SERVICE BULLETIN #3 HOUDINI SKILL SHOT FIX

May 15, 2018

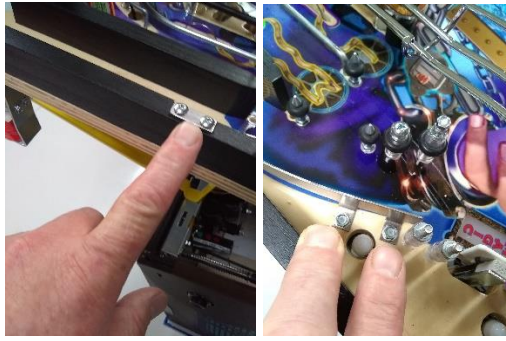
Remove the three 11/32 nuts, remove and disconnect the planchette and loosen the three Philips heads

Remove the two ¼" nuts holding the gate on and remove the gate.

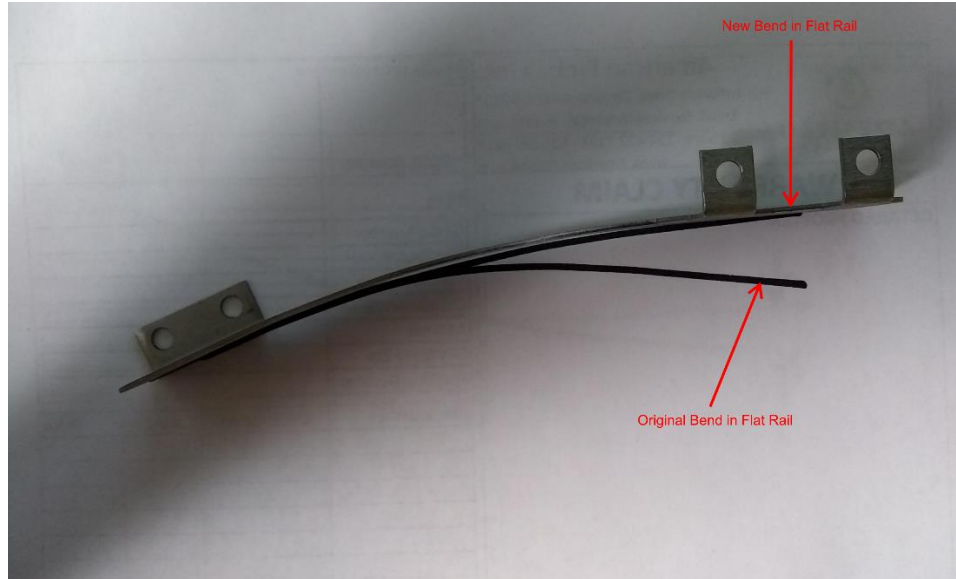
Remove the two Philips and two ¼" screws

Remove the flat rail and open the radius of the curve about 1 inch.

Remove the 7/16" rubber and insert the RBR0001-02. The post closest to the flat rail will no longer have a rubber on it.
The goal is to have the flat rail touching the post without the rubber on it.
